ADDENDUM #2

ATCAA Food Bank Walk-In Freezer Project RFP | November 17th, 2020

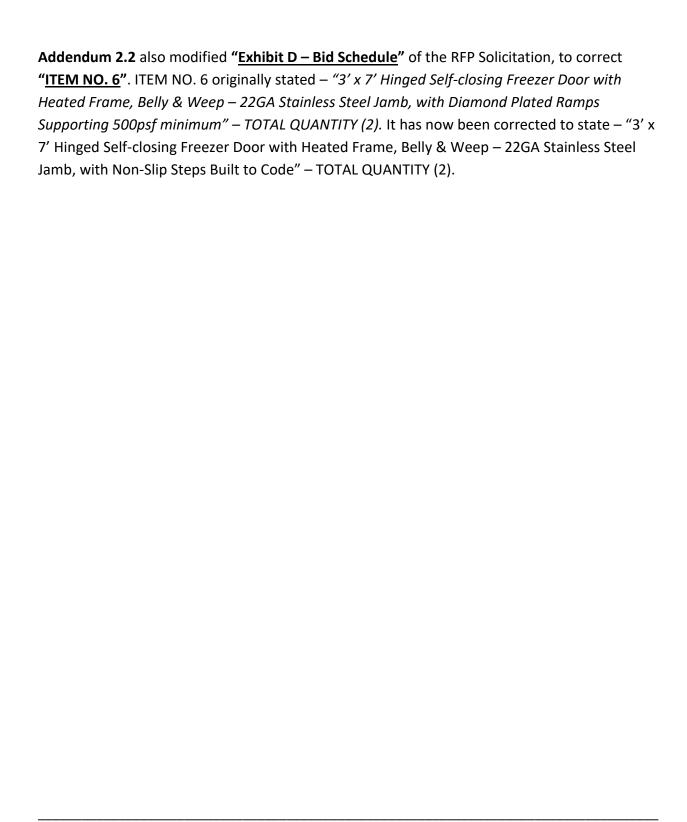
Addendum 2.1 modified "Exhibit C – Plans and Specifications / WALK-IN FREEZER SPECS – Core Requirements" of the RFP Solicitation, to correct the required specifications for the freezer pad. The original specifications stated "●5,000psf Rated Floor (Raised) – (12" Insulated Floor-Concrete on Foam) – (1). It has now been corrected to state "●5,000psf Rated Floor (Raised) – (Pad shall be engineered to meet or exceed freezer manufacturers specifications)".

Addendum 2.1 also modified "<u>Exhibit D – Bid Schedule</u>" of the RFP Solicitation, to correct "<u>ITEM NO. 4</u>". ITEM NO. 4 originally stated – "12" Insulated Floor-Concrete On Foam (5,000psf Rating)". It has now been corrected to state "Engineered Insulated Floor-Concrete on Foam (5,000psf Rating)".
